Subject: SQUEAKING NOISE FROM CLUTCH PEDAL WHEN DEPRESSED	Bulletin No: 05-002/06
	Last Issued: 4/26/2006

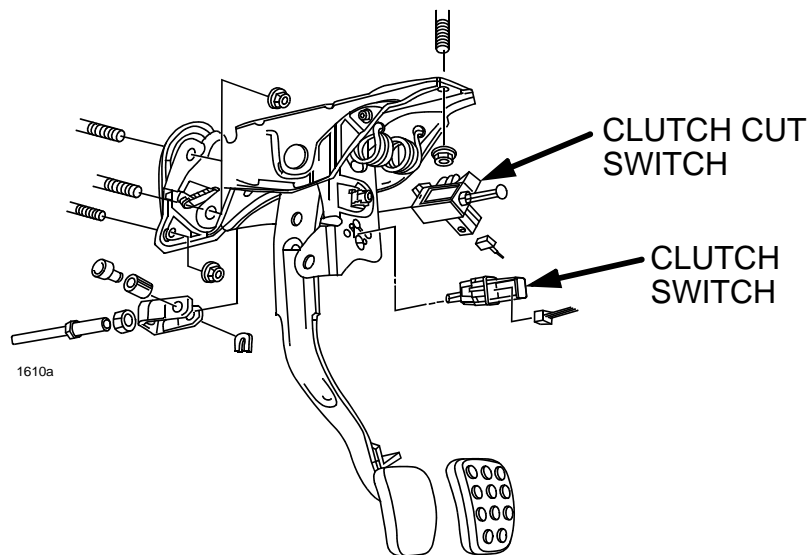
Some vehicles may exhibit a squeaking noise when the clutch pedal is depressed. The squeaking noise comes from the starter interlock switch.

As a mass-production change, the plastic material in the starter interlock switch has been changed. Customers having this concern should have their vehicle repaired using the following repair procedure.

1. Verify customer concern.
2. Replace starter interlock switch (referred to as Switch, Clutch Cut in EPC). See Workshop Manual section 05-10 CLUTCH PEDAL REMOVAL/INSTALLATION
3. Verify repair.
